DEVELOPMENT REVIEW BOARD
SUPPLEMENTAL SUBMITTAL

PROJECT NO. PR-2020-004761
Application No. SD-2021-00032

Preliminary Plat
 for
Lot 1-A, Block 33
Tract A, Unit B, North
Albuquerque Acres
 Being Comprised of
Lot 1, Block 33, Tract A, Unit B,
North Albuquerque Acres
 City of Albuquerque
 Bernalillo County, New Mexico
 February 2021

Re: Preliminary Plat Review for Proposed Lot 1-A, Block 33, Tracts A, Unit B, North Albuquerque Acres - (8310 San Pedro Dr. NE / Anaheim Ave. NE)

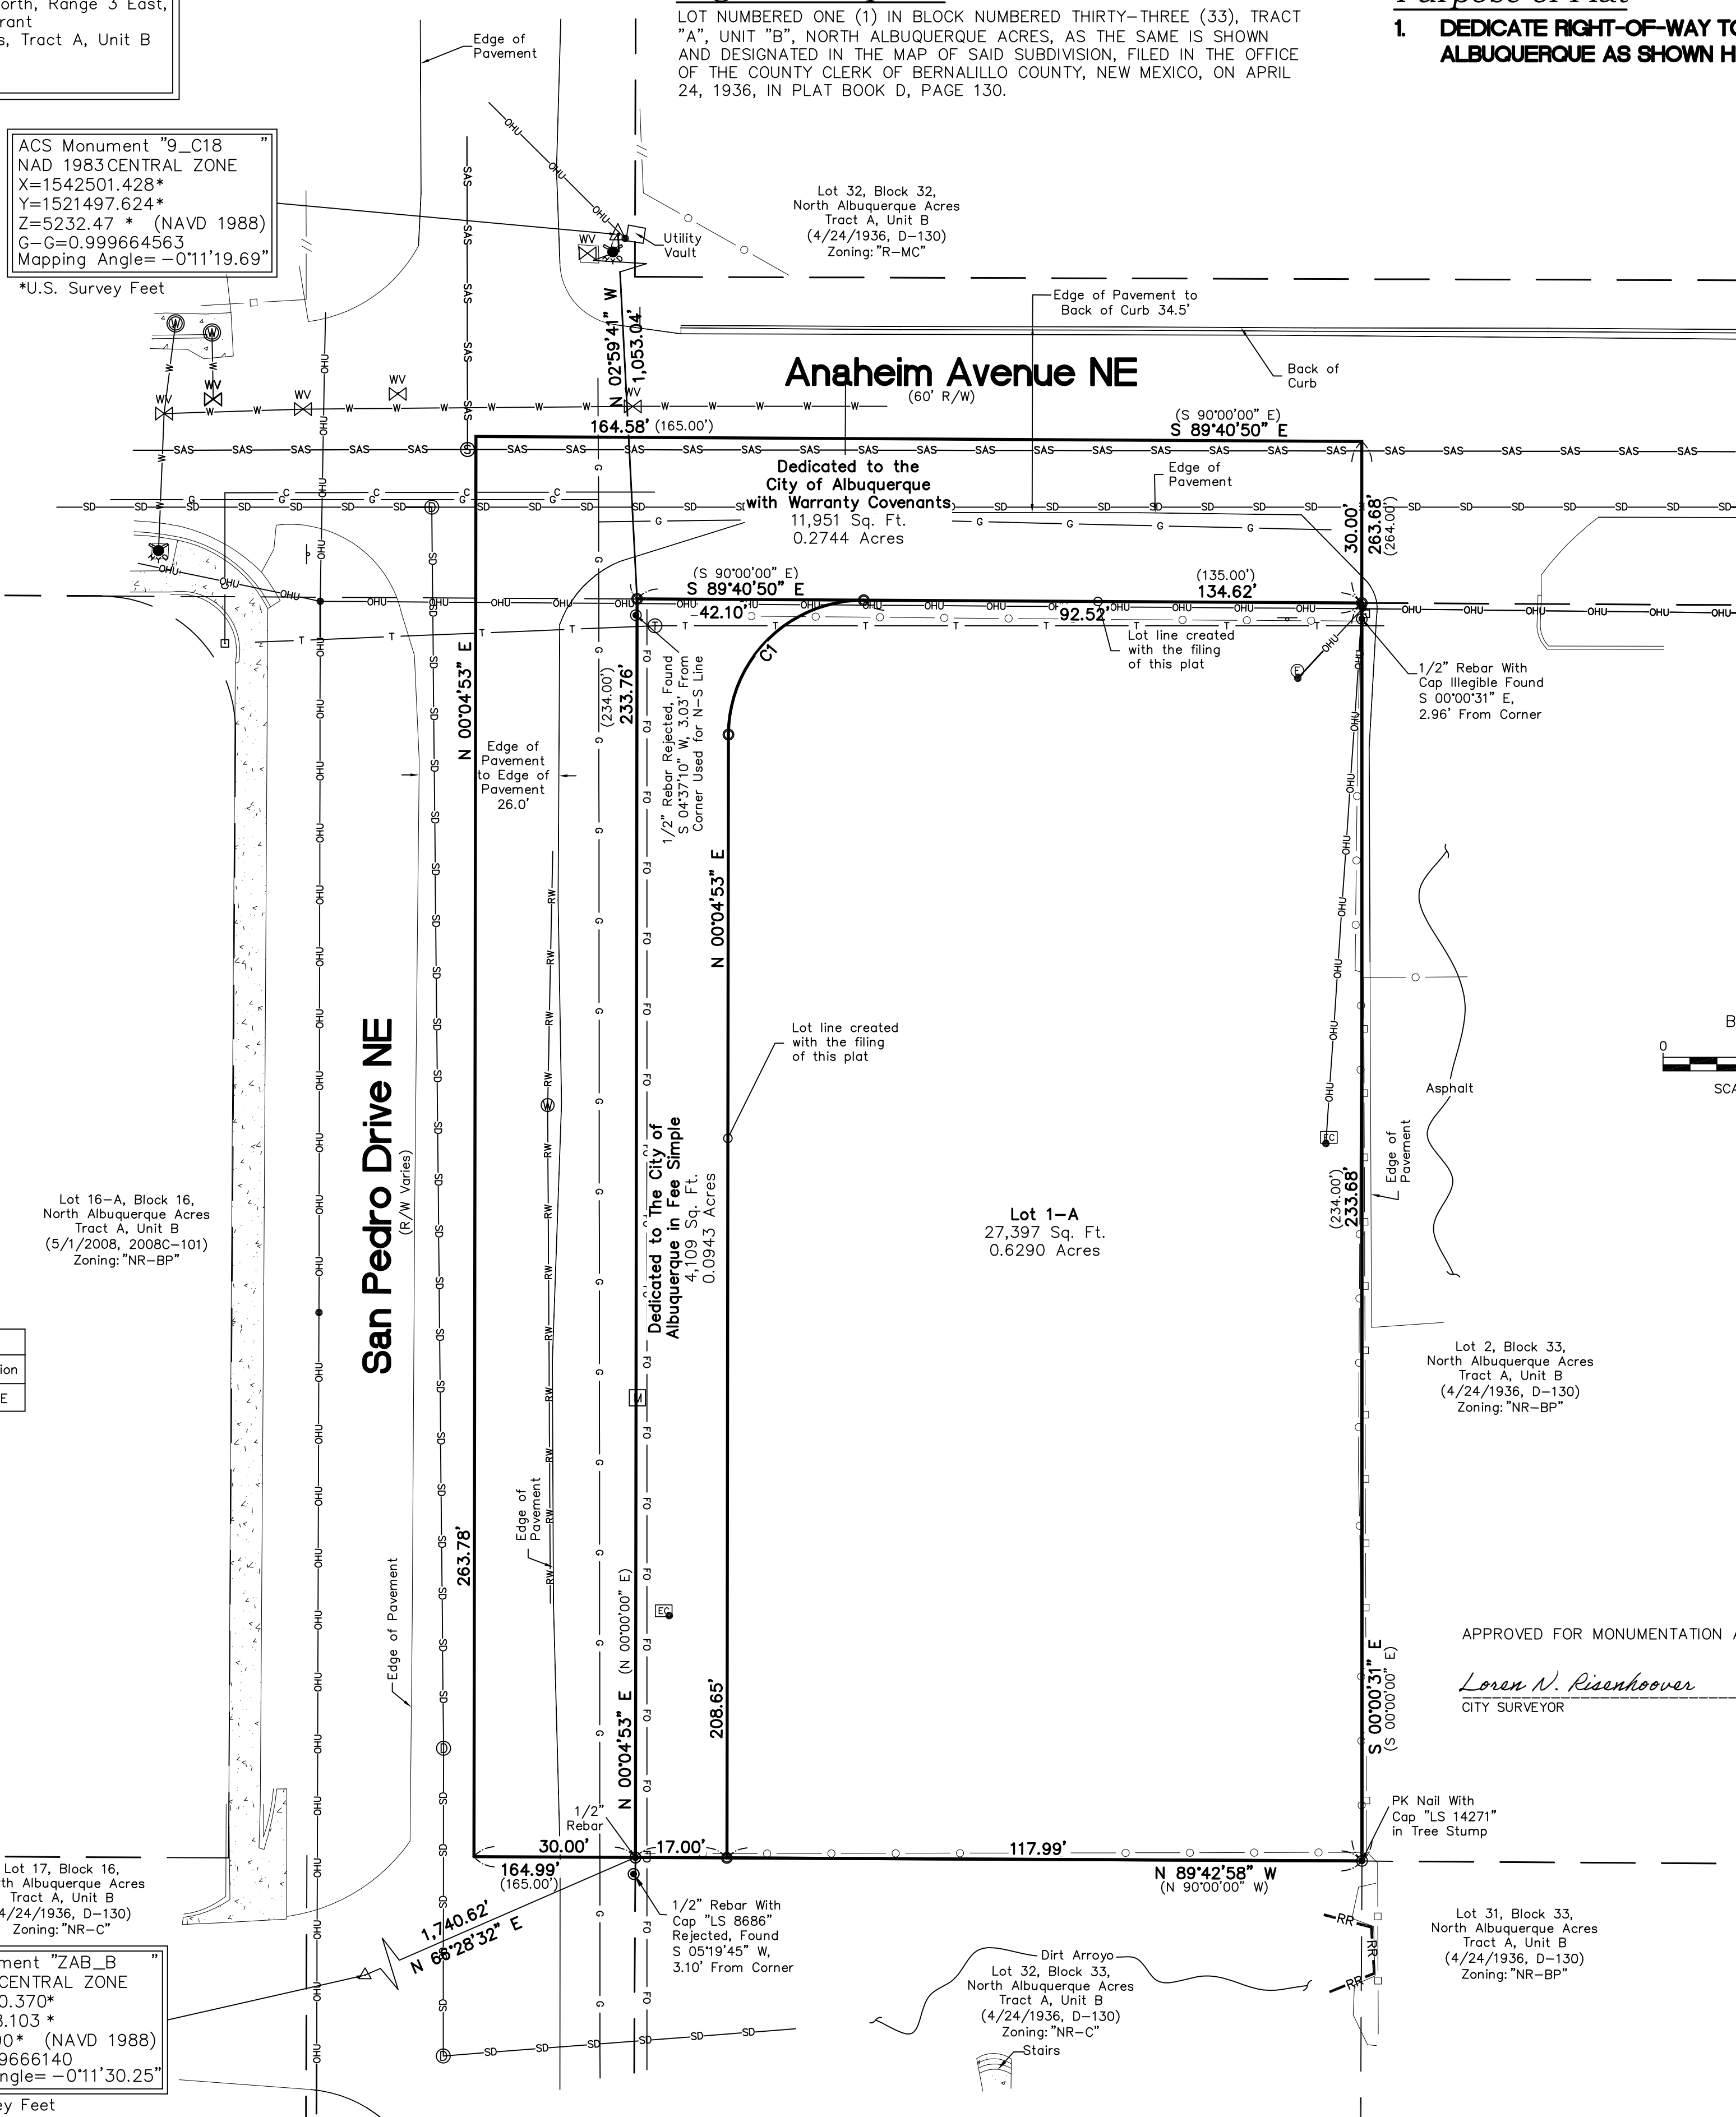
1. Add note that all roadway improvements shall be included as part of a Procedure C Agreement.

If right of way dedication is required a plat will be required to show that.
<http://www.cabq.gov/planning/boards-commissions/development-review-board>
see the DRB webpage for application details

Notes on the site plat should satisfactorily designate the roadway improvements as part of a Procedure C Agreement.

Noted, dedication is shown on Preliminary Plat

(A1) CONCEPTUAL GRADING AND DRAINAGE PLAN

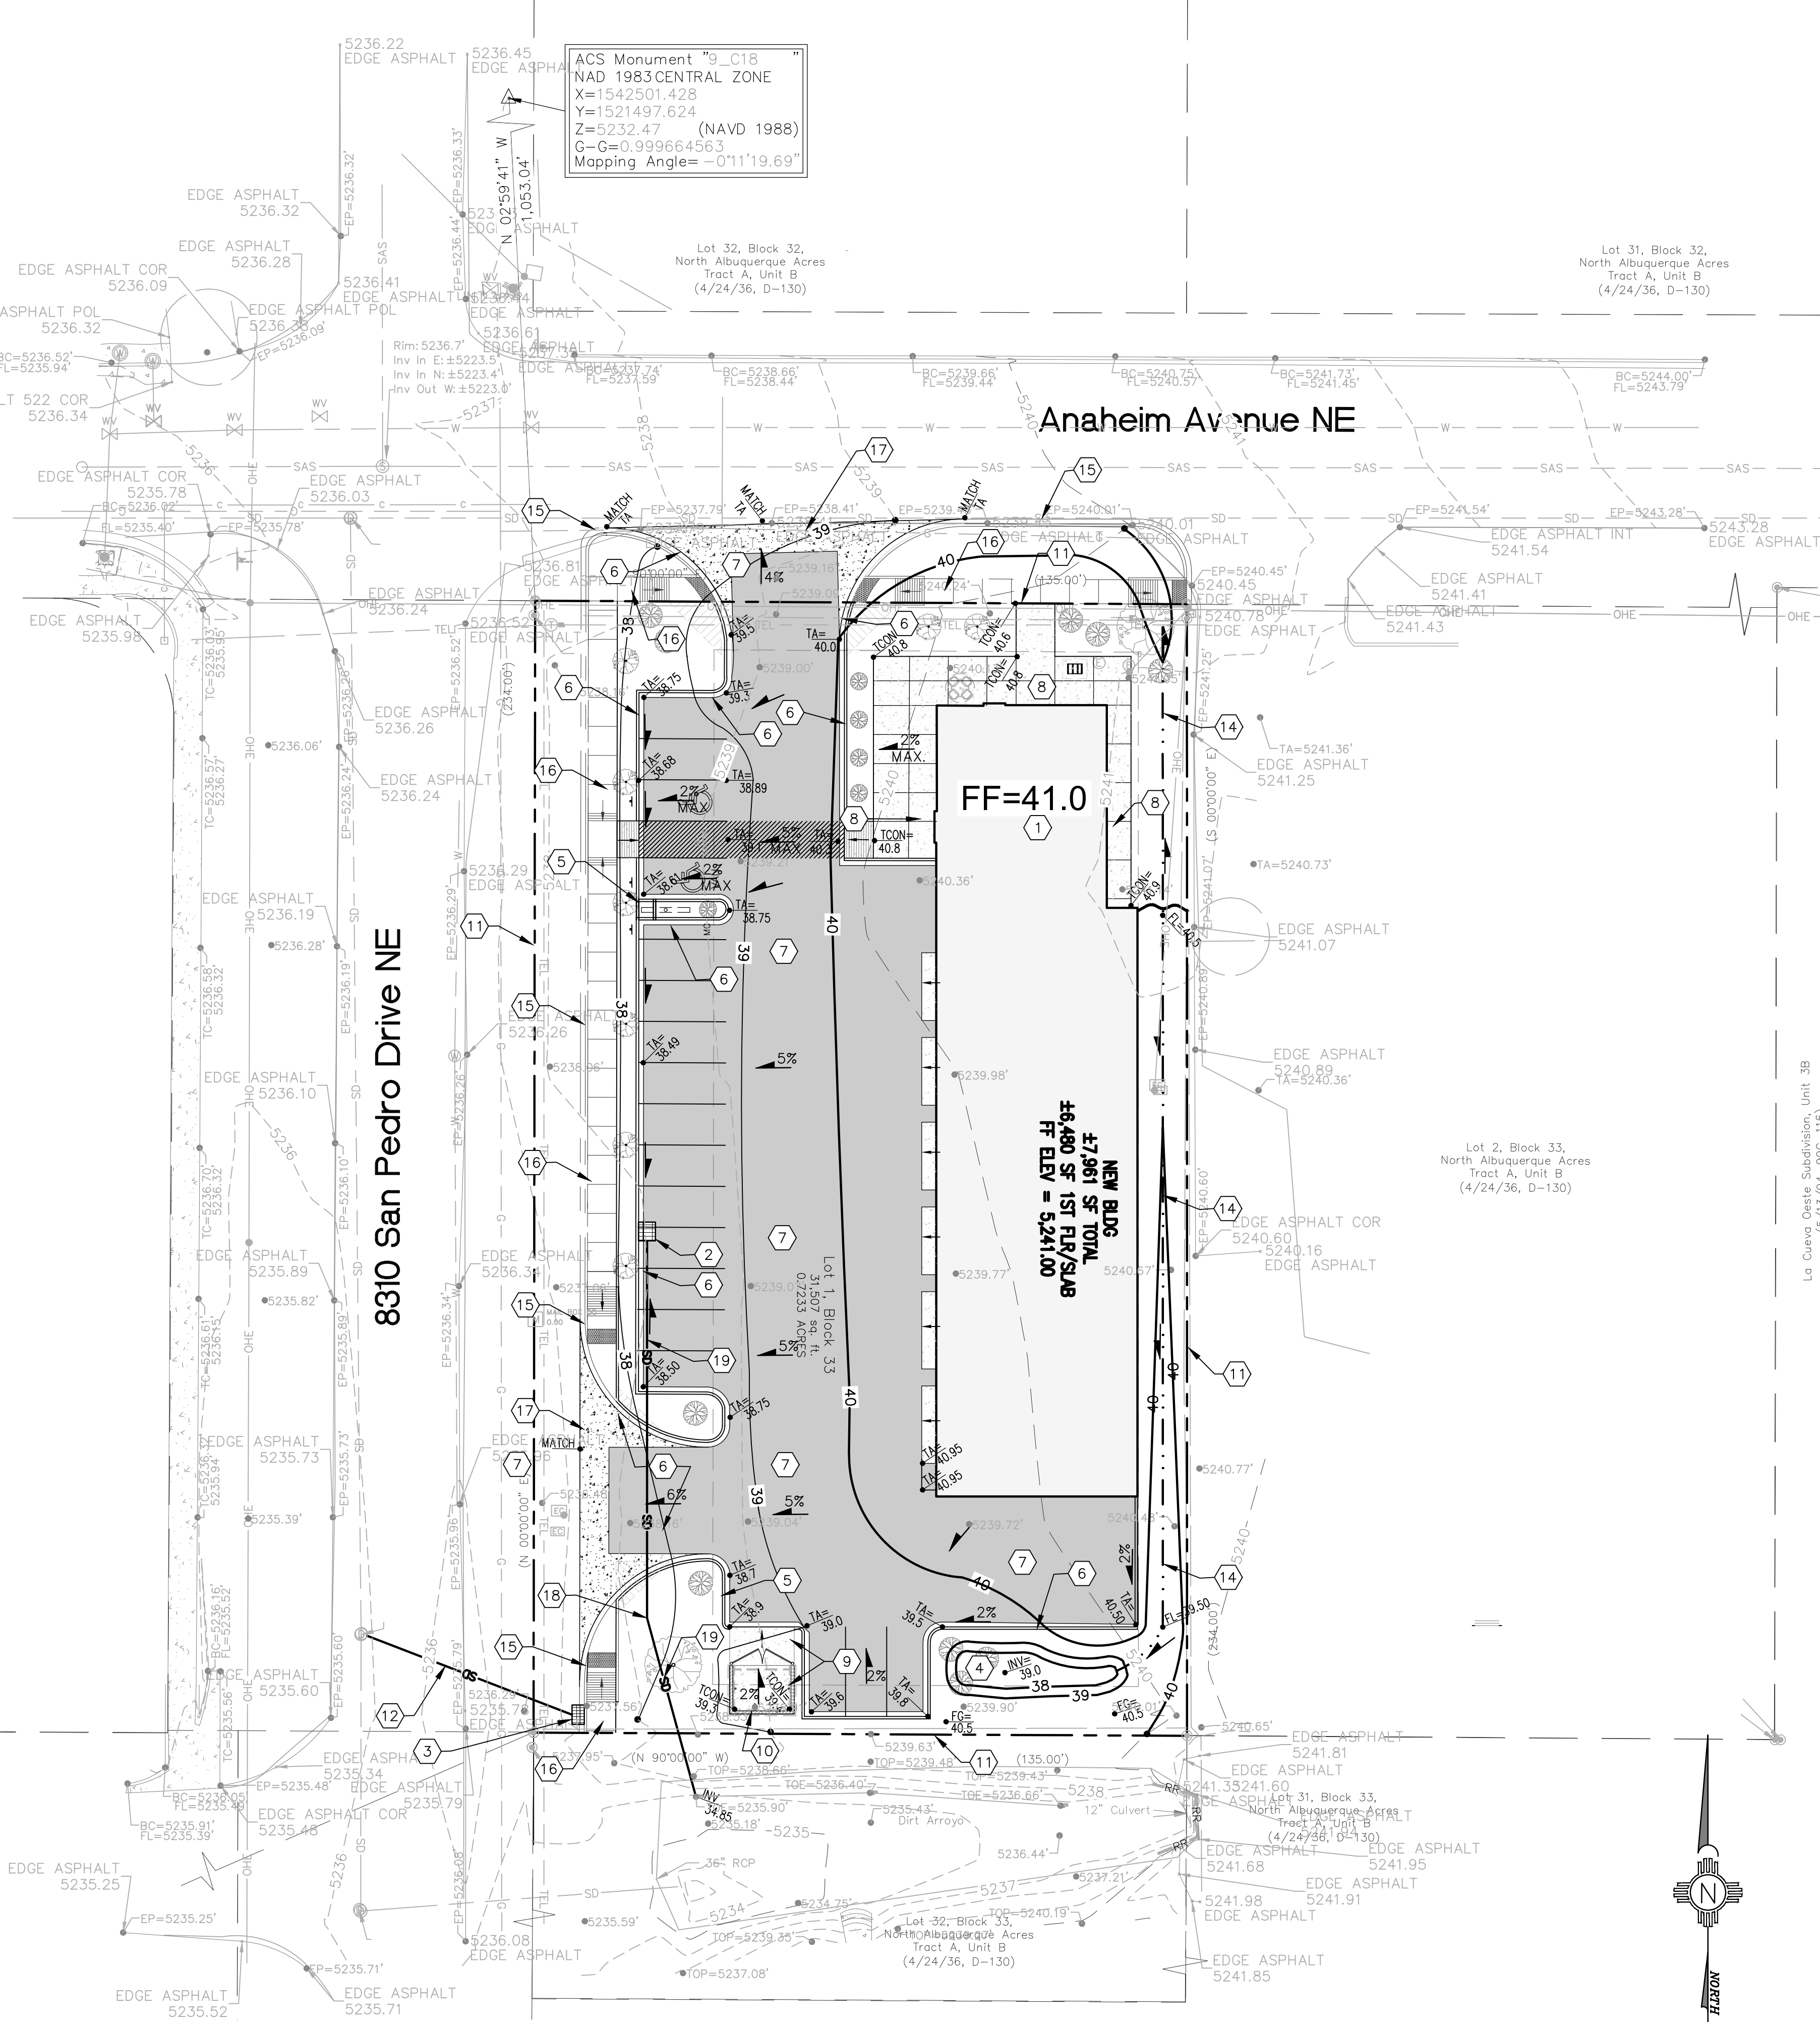
Hydrology will need to approve the Grading & Drainage Plan prior to approval of platting action or Infrastructure List.

Approved grading and drainage documents are attached.
